REVISED STAFF REPORT AND RECOMMENDATIONTO THE DESIGN COMMISSION

CASE FILE: LU 11-165918 DZM - Milano Apartments

LU 11-165918 02M Exhibit C.25

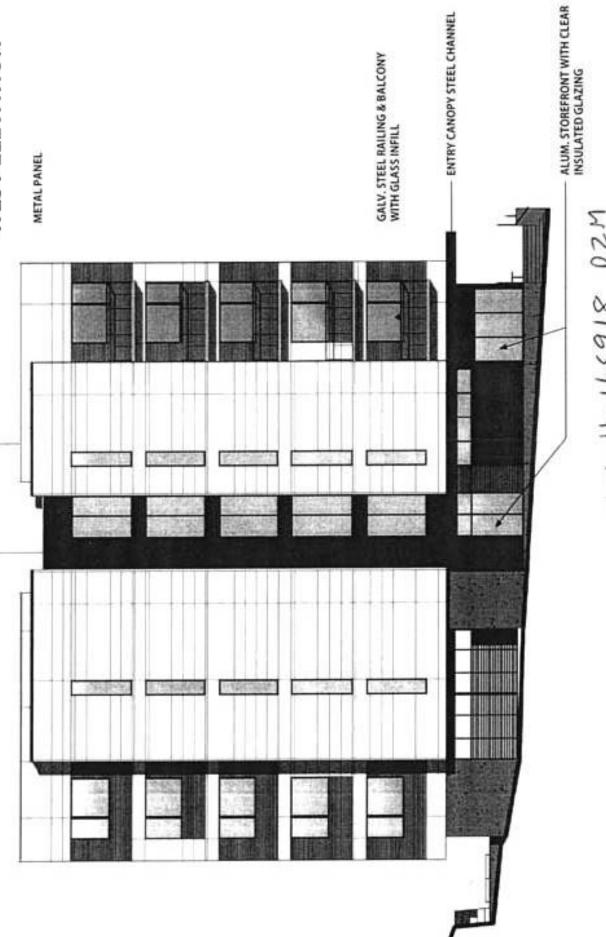
However, the design of the west elevation still bears the appearance of an 'end wall', that could be further integrated with the south elevation to create a more unified street presence from the intersection and surrounding area, especially given the visual prominence of the west façade from the nearby area and elevated freeway. Two individual through-wall louvers have been added to the exterior walls at each unit, such that each unit now has three through-wall louvers, creating a visual distraction and multiple locations for potentially difficult intersections with the Cera-Clad siding. The new main entry canopy and design of the ground floor better announces the entrance than the original design, but could be pursued further to better combine the two primary street-facing facades. Similarly, the design of the upper floors on the two street-facing facades appear overly distinct and anomalous when compared to one another, and could benefit from are further integration through additional design moves such as common window types, coloration in siding patterns, or other features which create a more unified street presence.
